April 15, 1999
SCI 447.055

**Work Plan
Groundwater Monitoring and
Expanded Corrective Action Plan Preparation
Connell Automotive Dealership Facility
3093 Broadway (STID# 469)
Oakland, California**

SITE PLAN			1
CONNELL OLDSMOBILE - OAKLAND, CA			
JOB NUMBER 447.055	DATE 4/15/99	APPROVED <i>men</i>

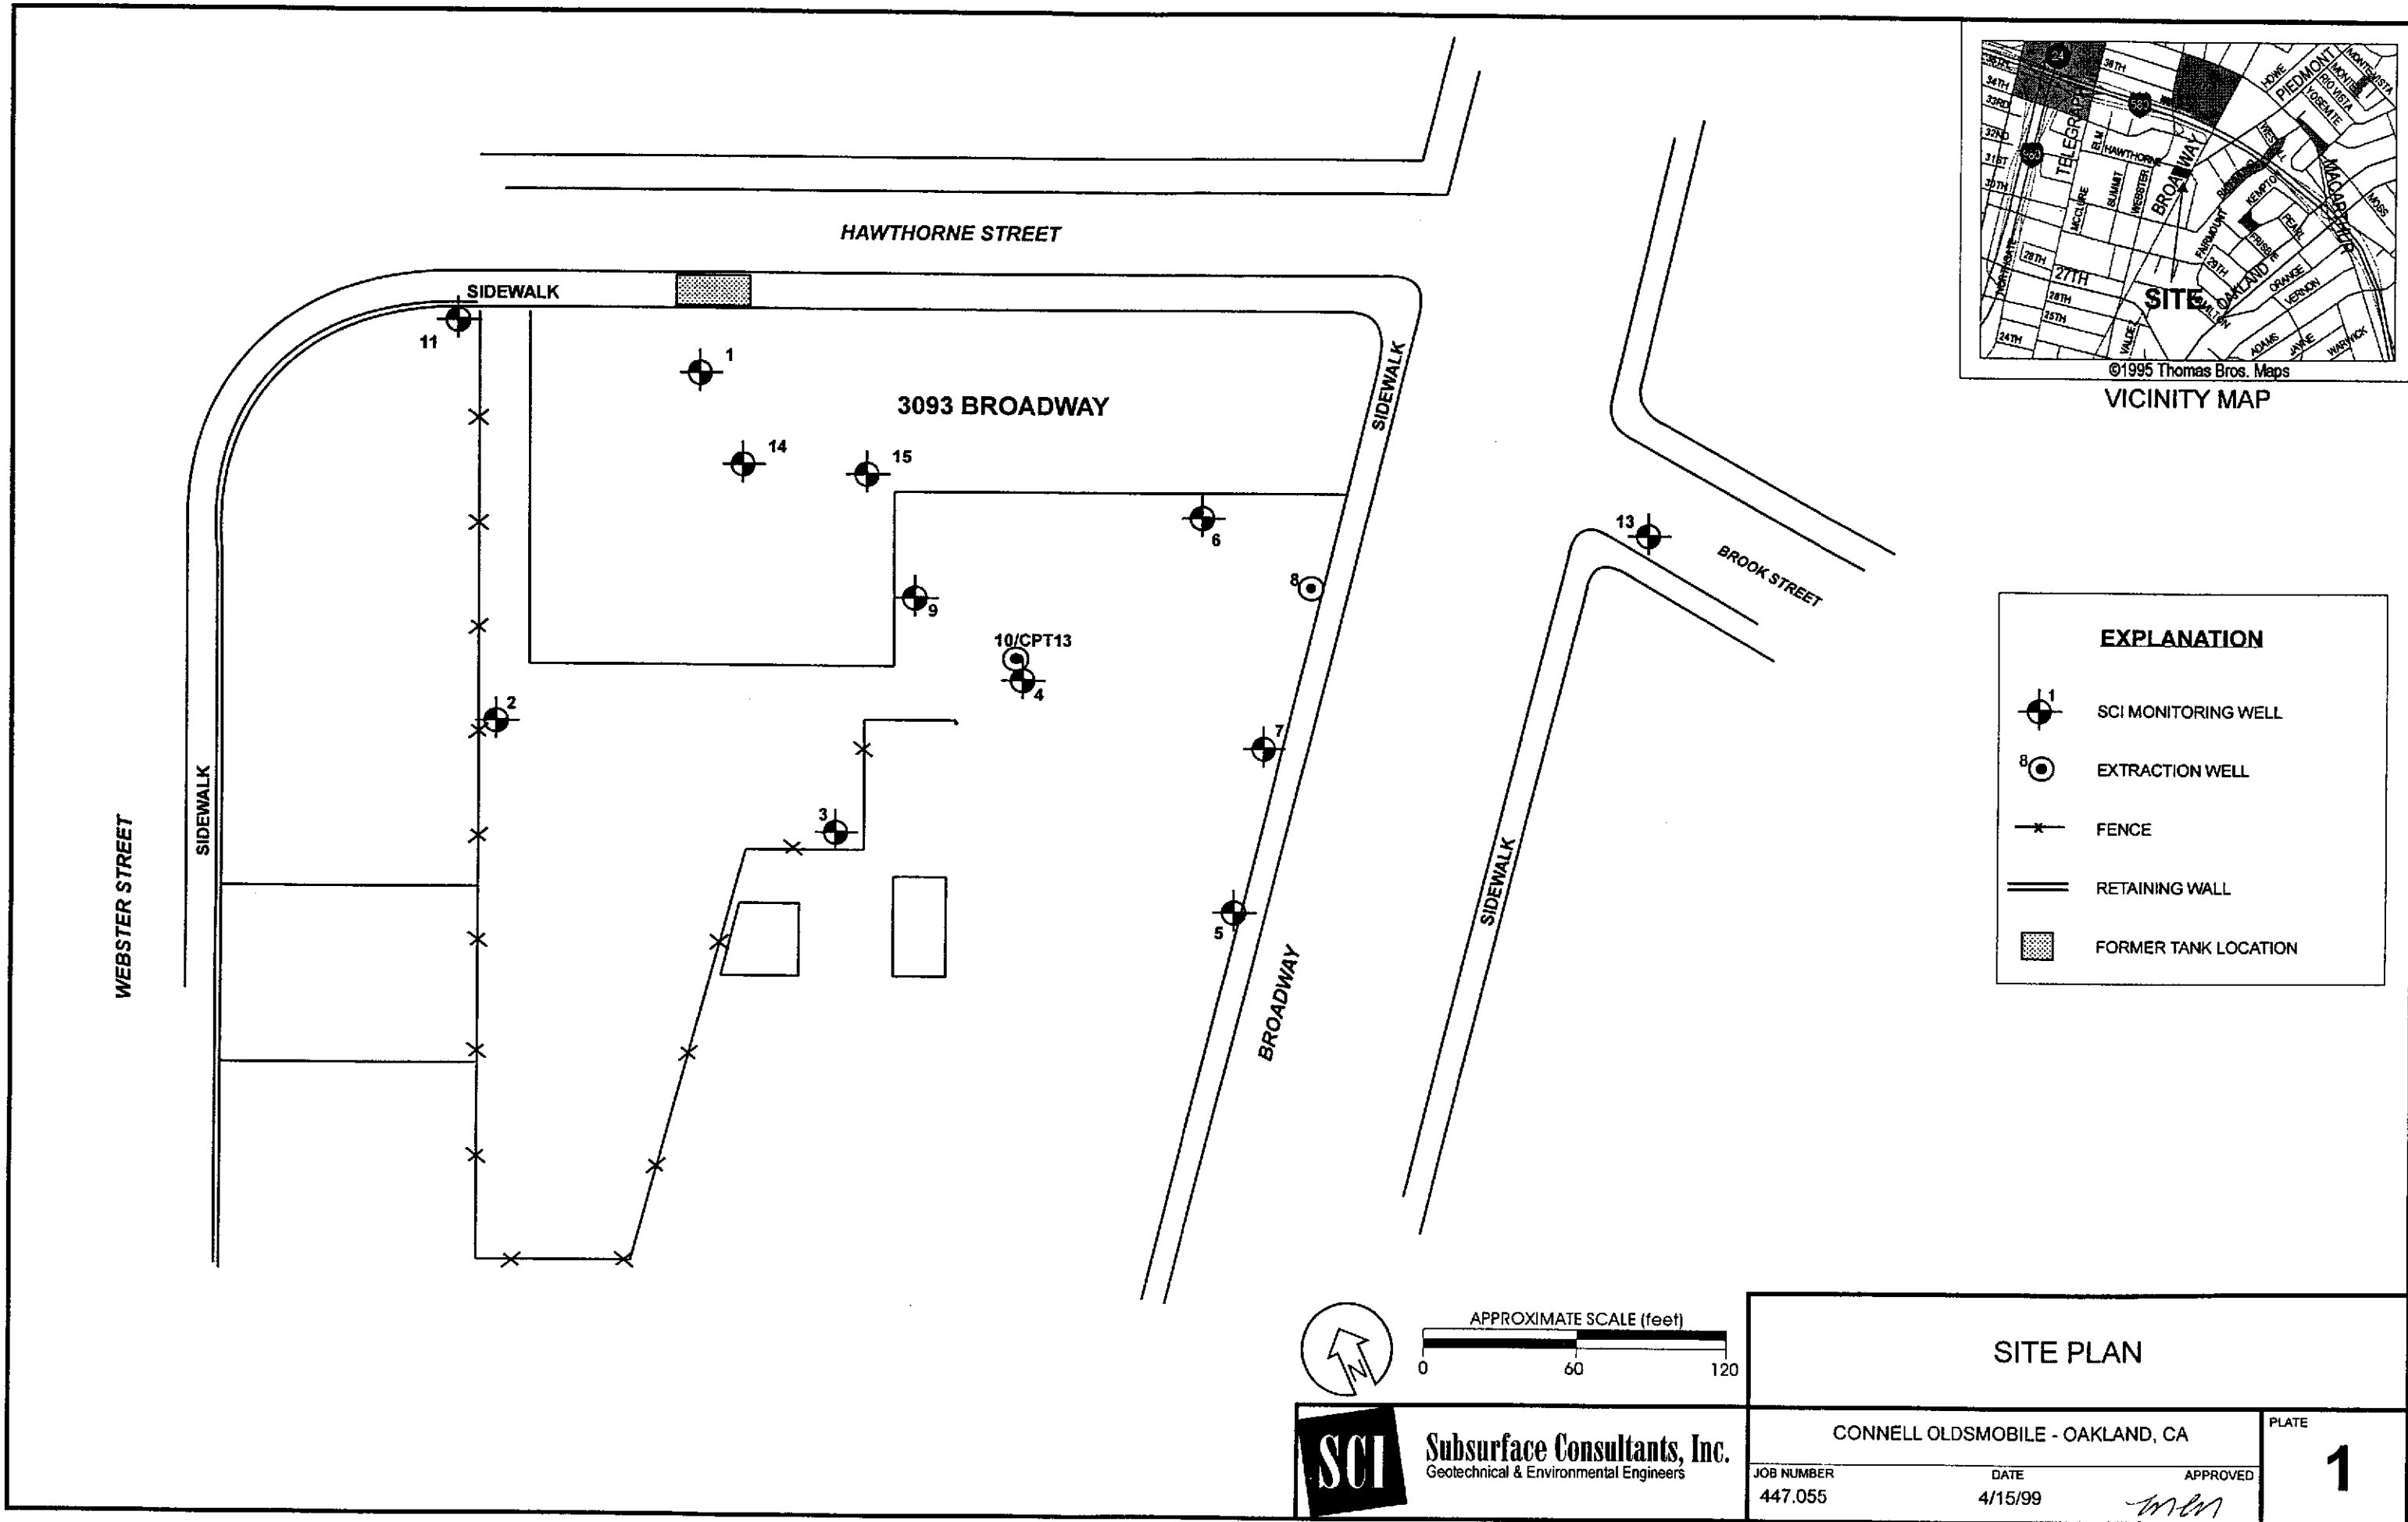
MW-14 (new well inside bldg. like FP)
